Subject: Bid Package #1
Borel Middle School HVAC Replcmt-DSA 01-119557
College Park Elementary School HVAC Replcmt-DSA 01 119530
Meadow Heights Elementary School HVAC Replcmt DSA 01-119554
North Shoreview Montessori School HVAC Replcmt DSA 01-119526
San Mateo - Foster City School District

ADDENDUM NO. 1

Subject: Borel Middle School HVAC Replacement
San Mateo - Foster City School District
Aedis Project No. 2021005
DSA Application #01-119557

ADDENDUM NO. 1

SHEET # AD1-
MP2.01

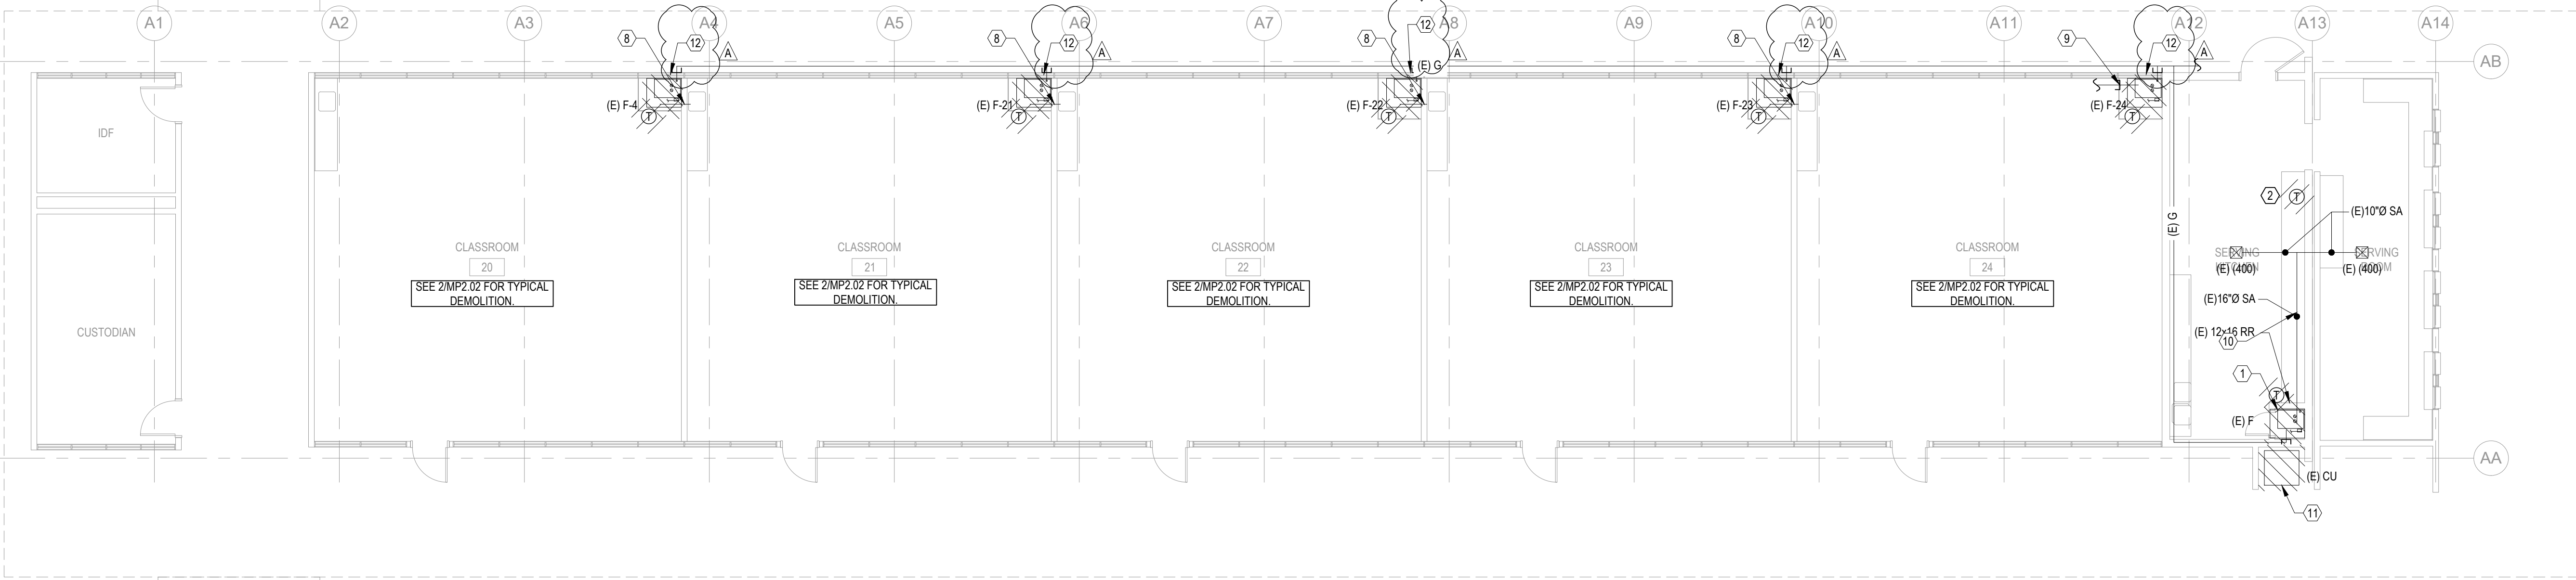
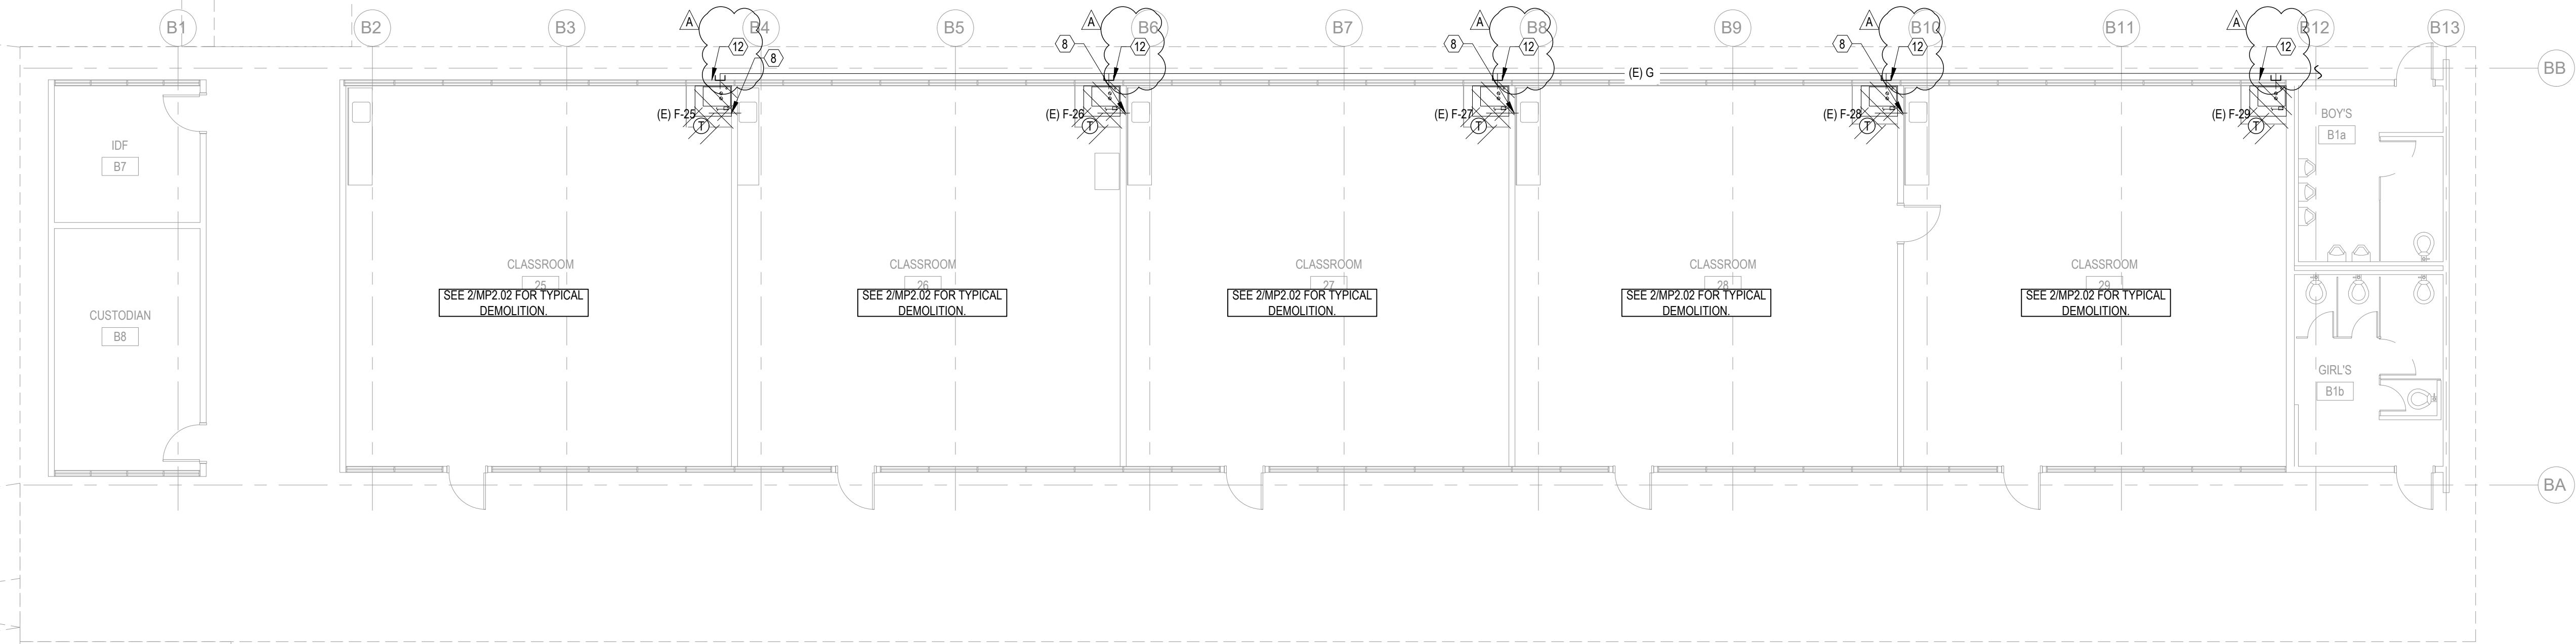
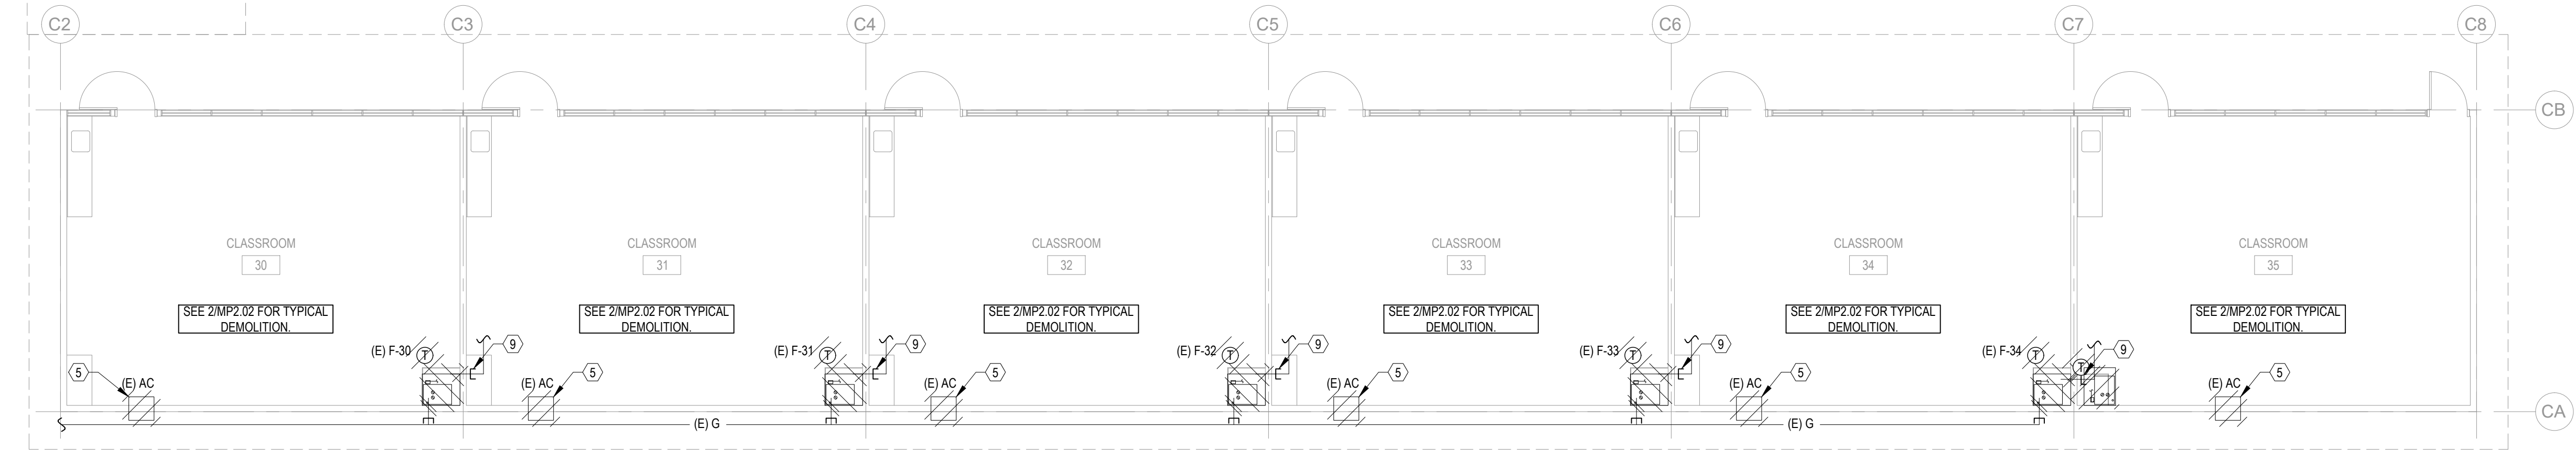
Add: Cap Bottom Louver per AD1-MP2.01

Add: Demolition Sheet Notes #12 per AD1-MP2.01

SHEET # AD1-
MP6.02

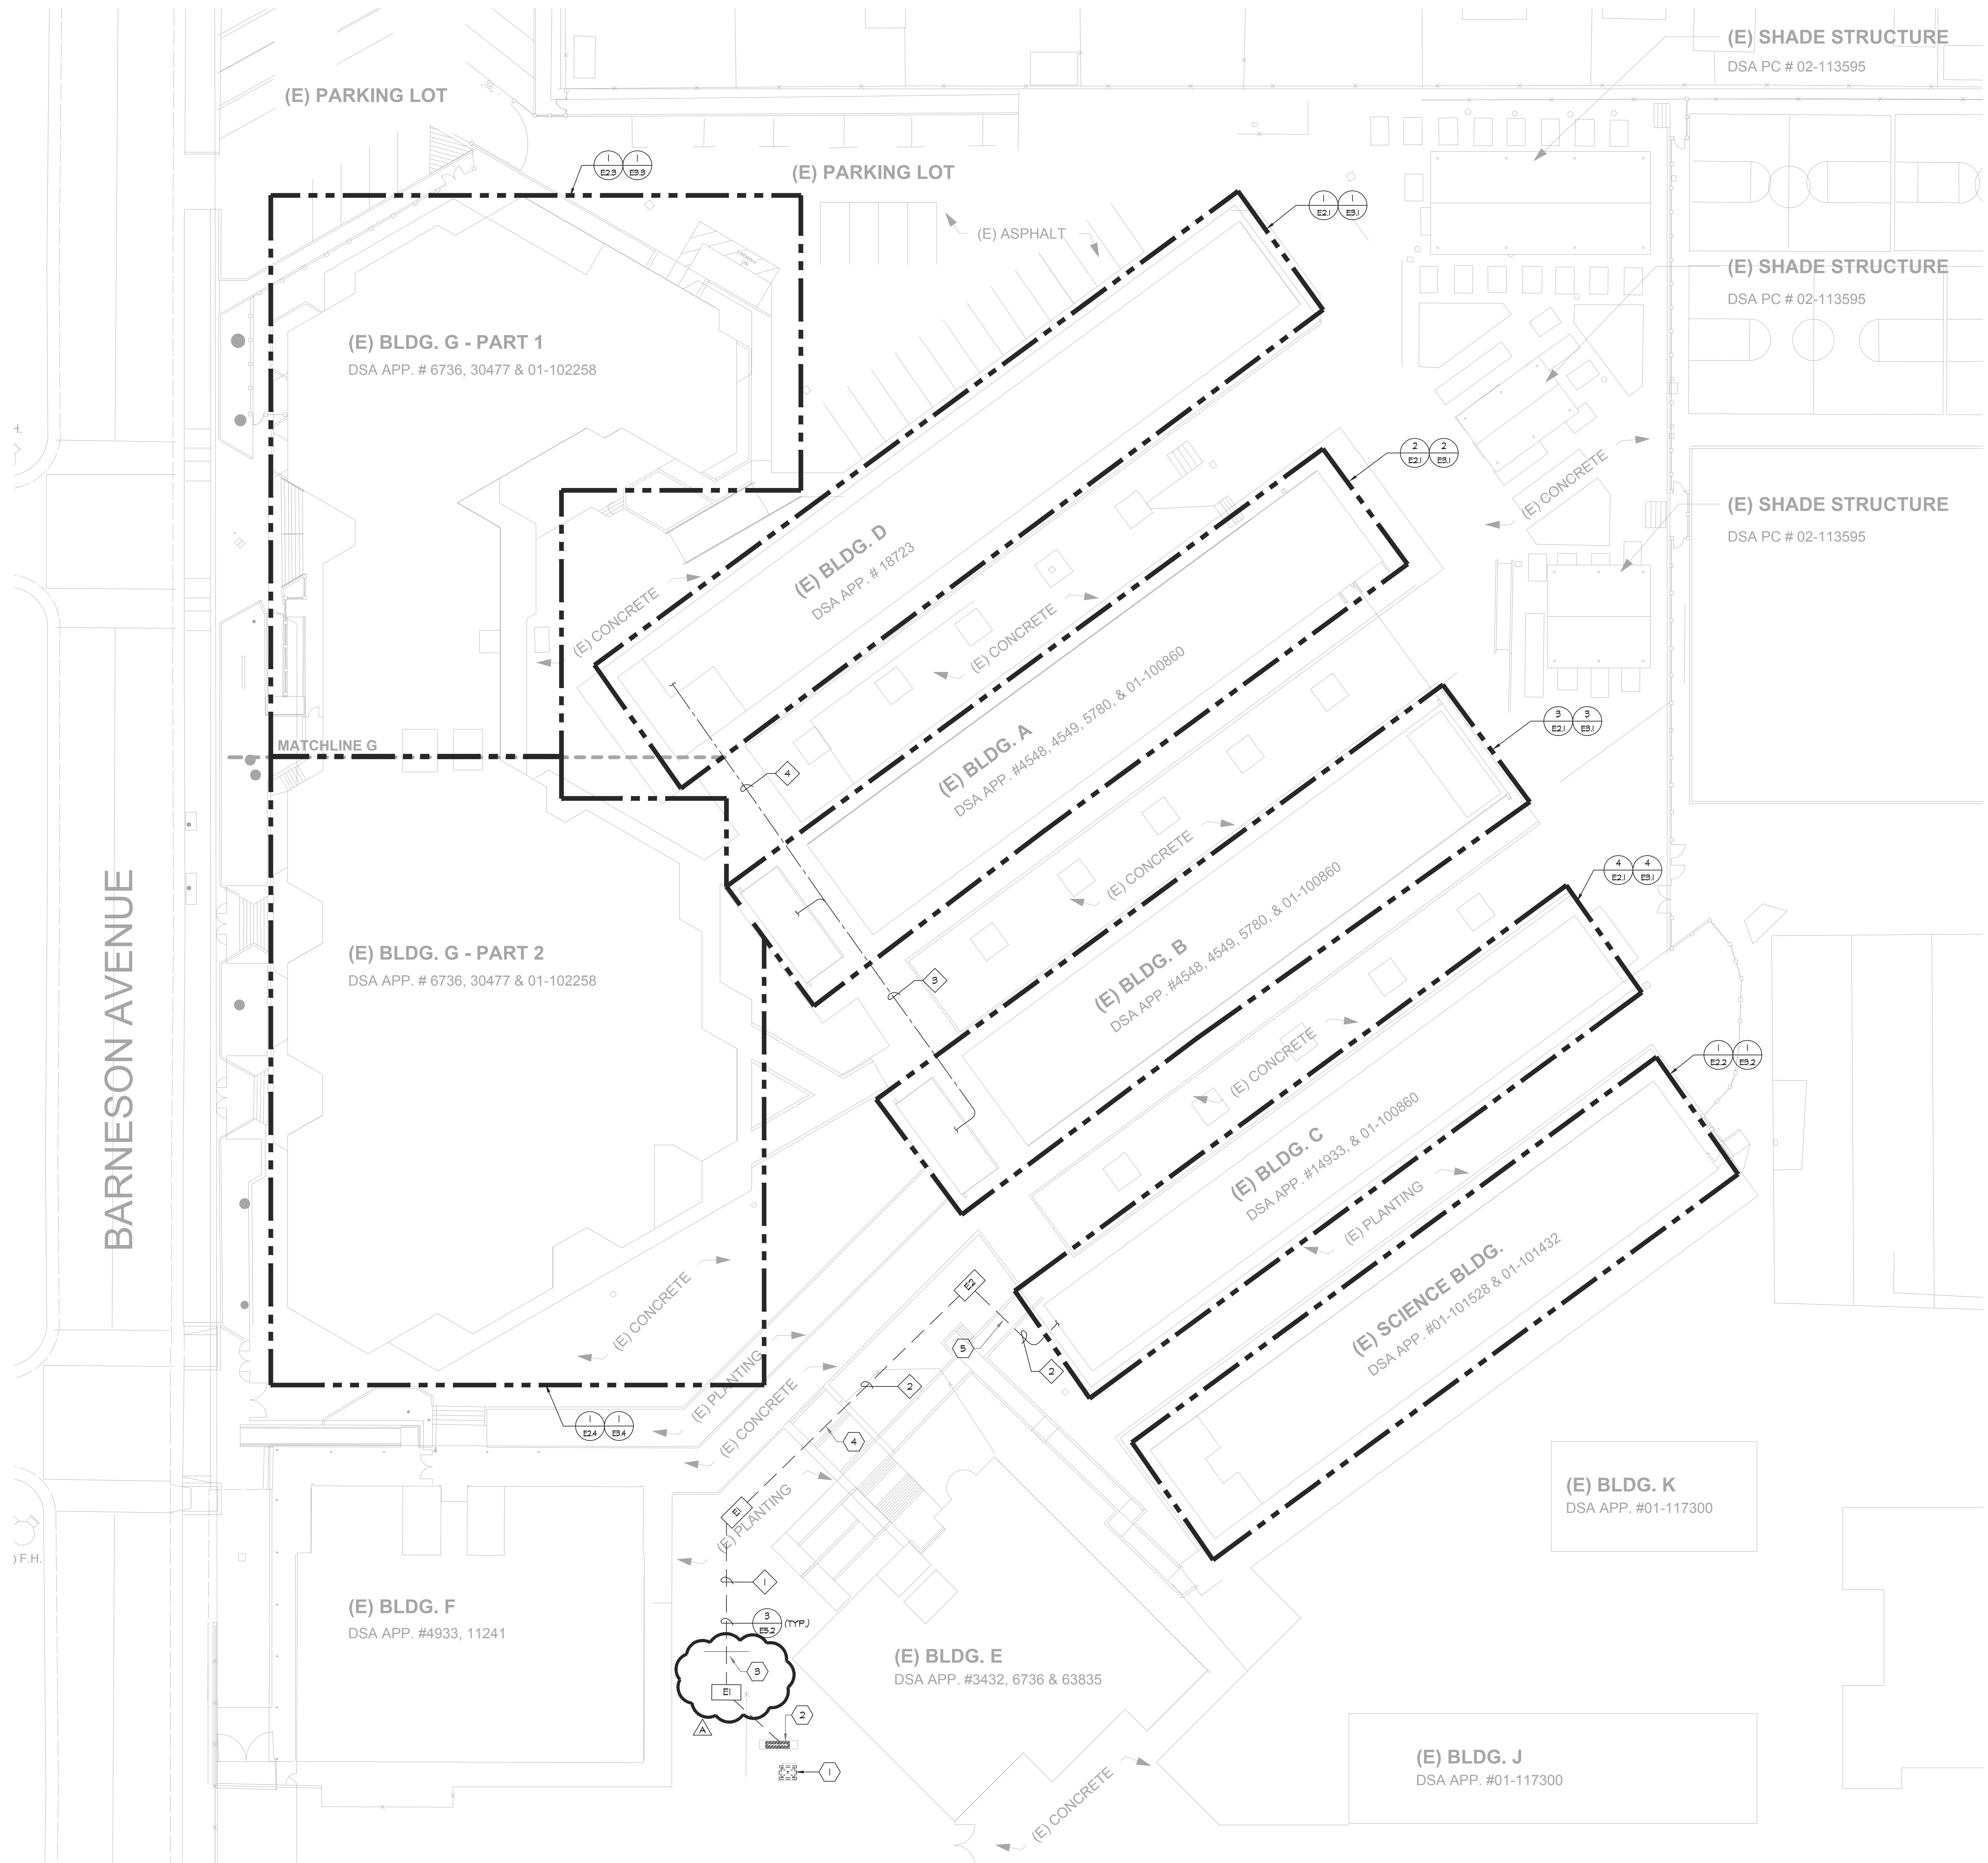
Add: New sheet in its entirety per AD1-MP6.02
